Product / Process Change Notification (PCN)	
<input checked="" type="checkbox"/> Major Change <input type="checkbox"/> Minor Change	
PCN Number: PCN_FeSTAR-Series_20250101 Affected Series: WE-STAR-Series Affected Order Codes: see tables below PCN Date: 2024-10-01 (YYYY-MM-DD) Effective Date: 2025-01-01 (YYYY-MM-DD)	Change Category: <input type="checkbox"/> Equipment/Location <input checked="" type="checkbox"/> General Data <input type="checkbox"/> Material <input type="checkbox"/> Process <input type="checkbox"/> Product Design <input type="checkbox"/> Shipping/Packaging <input checked="" type="checkbox"/> Supplier <input type="checkbox"/> Software
Contact: Product Management Phone: +49 (0) 7942 - 945 5001 Fax: +49 (0) 7942 - 945 5179 E-Mail: pcn.eisos@we-online.com	Datasheet Change: <input checked="" type="checkbox"/> Yes <input type="checkbox"/> No Attachment: <input checked="" type="checkbox"/> Yes <input type="checkbox"/> No

Description of change: For the purpose of a datasheet information enlargement and internal standardization, Würth Elektronik will implement a new measurement setup to improve the accuracy and extend the comparability of values. Additionally, the operating

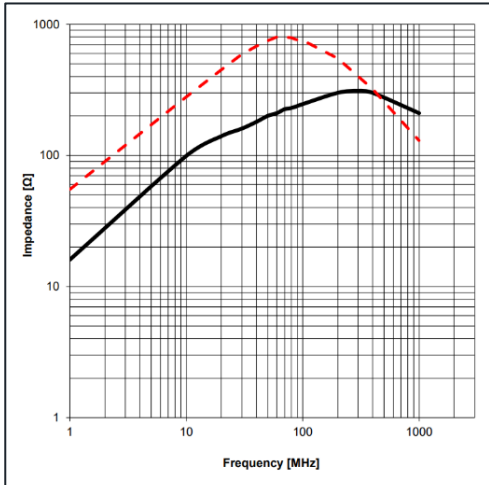
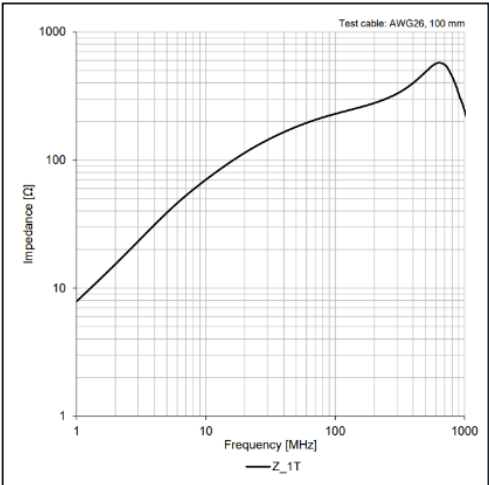
3. The visualization of chart for the **“Typical Impedance Characteristics”** changes. The used type of cable and cable length is shown in each chart.

Before change:	After change:
<ul style="list-style-type: none"> Showing only one graph with 1 turn (1T) and 2 turns (2T) impedance curves. 	<ul style="list-style-type: none"> Showing a graph for the 1 turn (Z_1T) impedance curve with the shortest possible cable length according to the product.

Showing no graph with 3 turns impedance curve.

Showing a graph for 1-3 turns (Z_{1T} , Z_{2T} , Z_{3T}) impedance curves with the shortest possible cable length, which is required for 3 turns according to the product.
